# CITY OF SAN ANTONIO

Re: Highlands Farms

POADP # **678**

**HIGHLAND FARMS SUBDIVISION  
 PRELIMINARY OVERALL DEVELOPMENT PLAN**

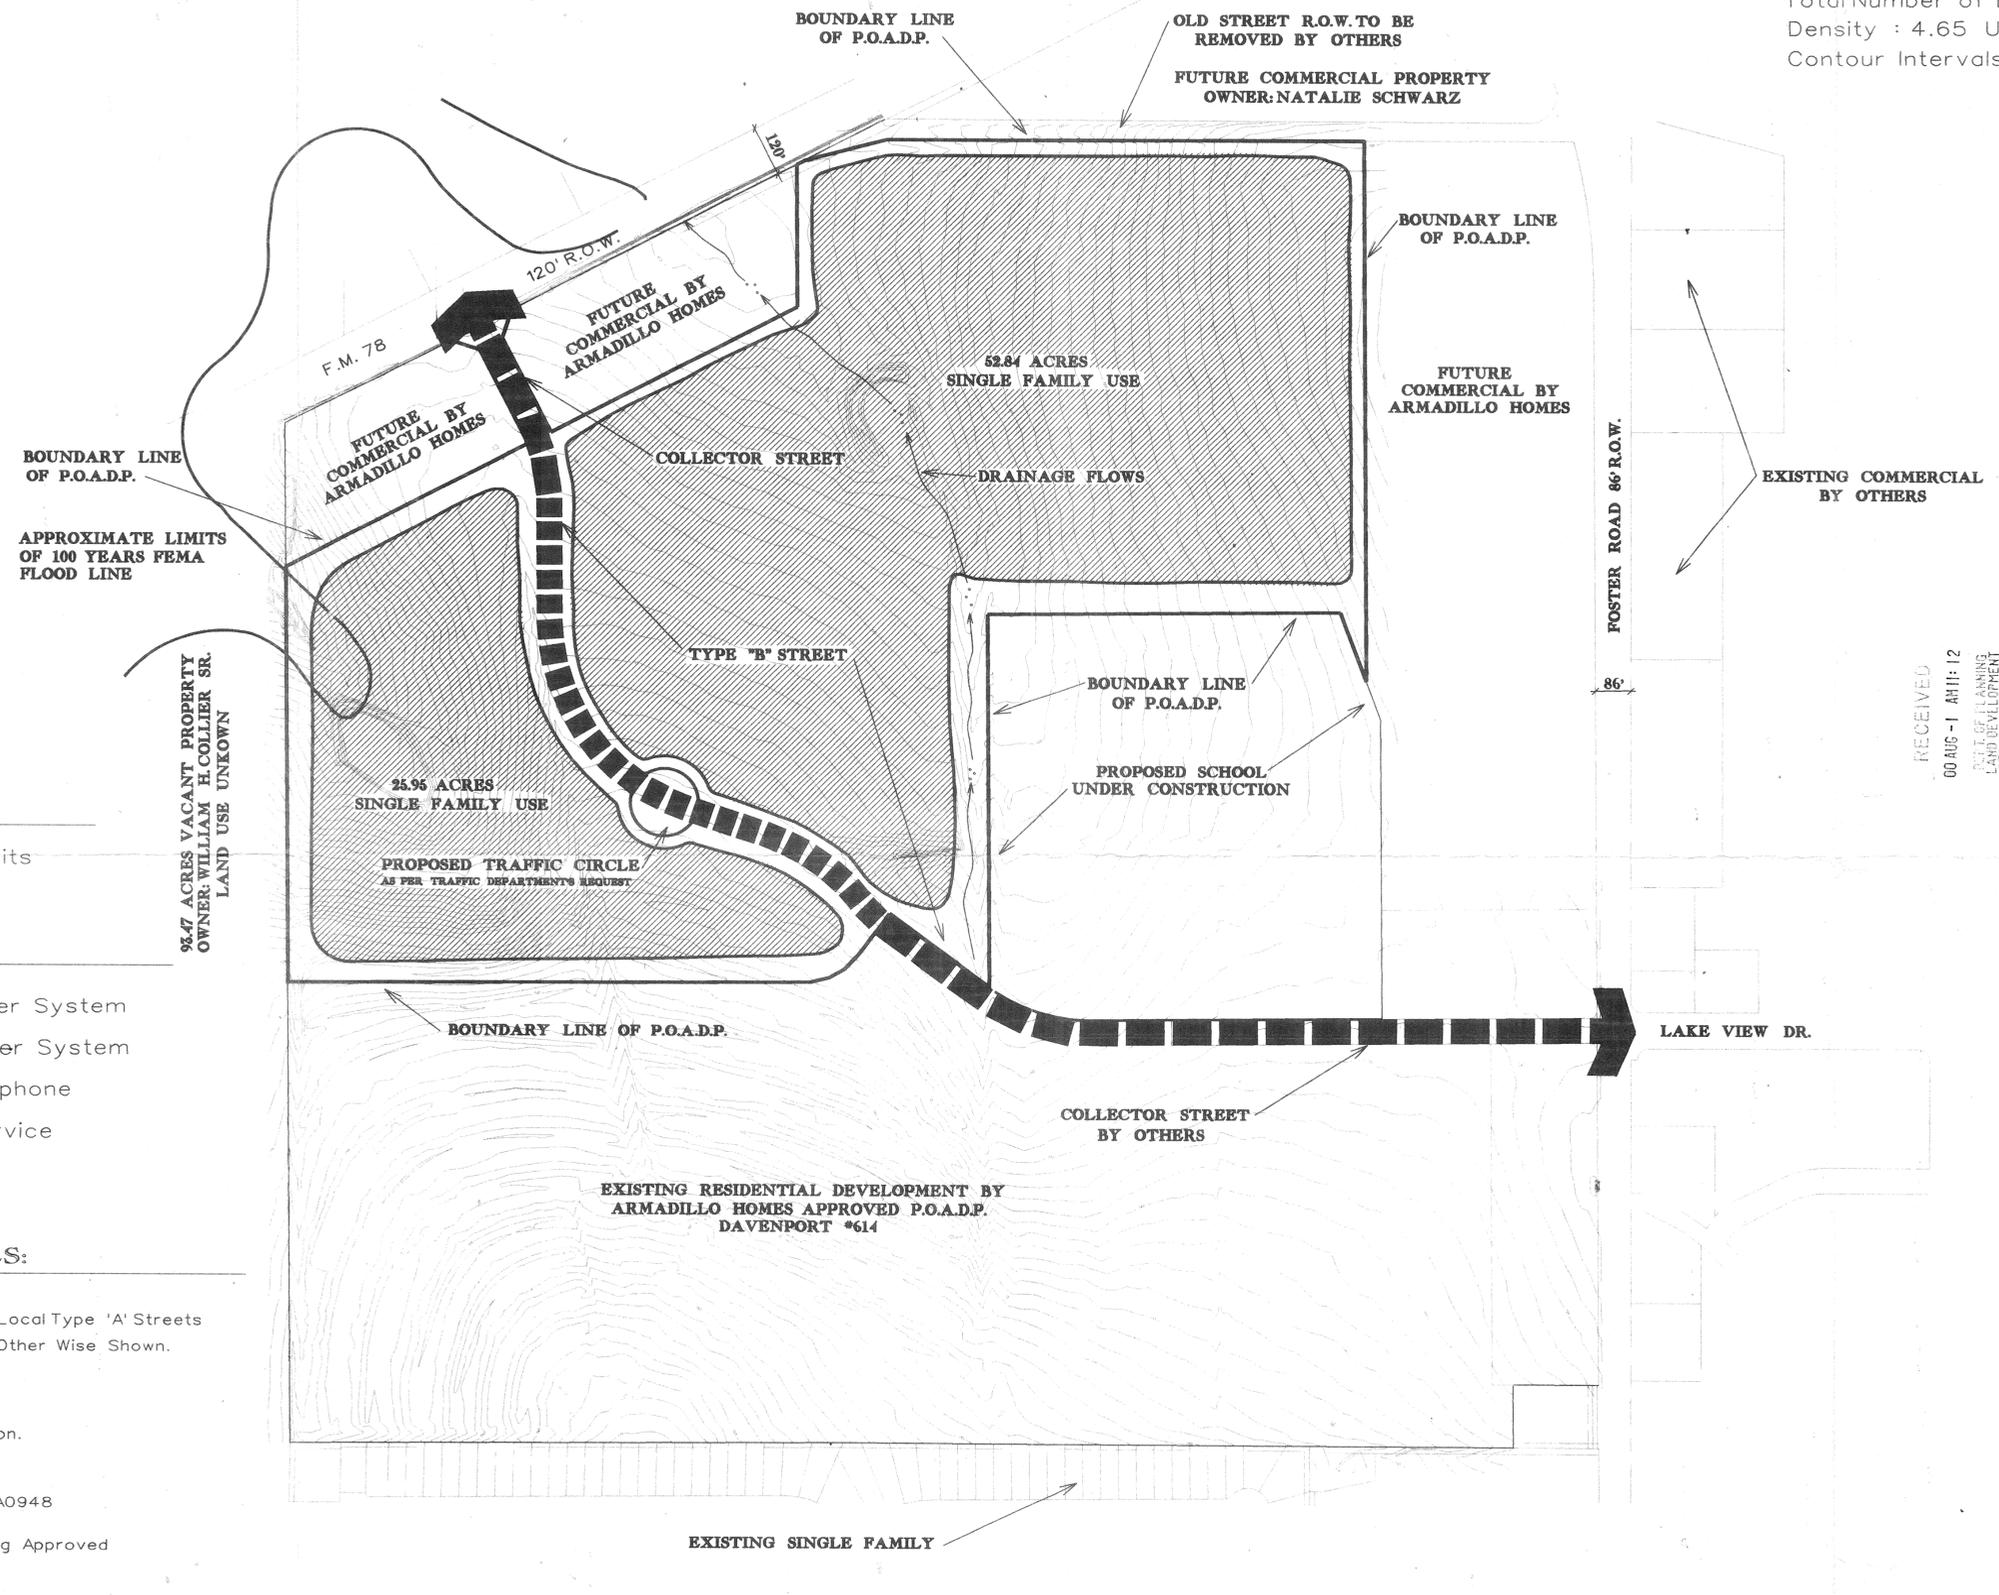
- Based on the topography, a Flood Plain Study and drainage review will probably be required during the platting process. Bexar County Public Works may require base flood elevations at the plat level.

- In consideration of public safety and convenience, excessive grades by reason of topography should be avoided in street layouts and arrangements.
- Access and R.O.W. issues along State facilities will need to be resolved with the Texas Department of Transportation (TXDOT). For information about these requirements you can contact TXDOT at 615-5814.

- This development will need to comply with tree preservation ordinance #85262. For information about these requirements you can contact Building Inspections at 207-7102.

- It will be expected that you will plat all of the property depicted in your POADP, to include: floodpains, drainage areas and open space.
- I would encourage you to work closely with the school district, so that they can plan accordingly.

(a) Perimeter property lines. **Are not clear and distinct.**

(d) Proposed land uses by location, type and acreage. **Was not clearly identified.**

(e) Existing and proposed circulation system of collector, arterial, and local type B street and their relationship to any adjacent major thoroughfares; and any proposed alternative pedestrian circulation system. **Were not provided.**

(1.1) the collector street needs to be broken ( via a traffic circle ) in order to control traffic speed. This was part of the original approval (Davenport #614).

(f) Contour lines at intervals no greater than ten (10) feet. **Were not clearly (legible) identified.**

(h) Existing adjacent or perimeter streets (including right-of-way widths), intersections, and developments. **Were not provided.**

(d) Paragraph, (2) The resulting additional ingress and egress of vehicles **Will** seriously disrupt the flow of traffic on the thoroughfare. A 1'-non accesses esm't will be required on the properties adjacent to the proposed collector.

- 3.) Access needs to be provided to the adjoining properties for connectivity.
- 4.) The digital file was missing from submittal.
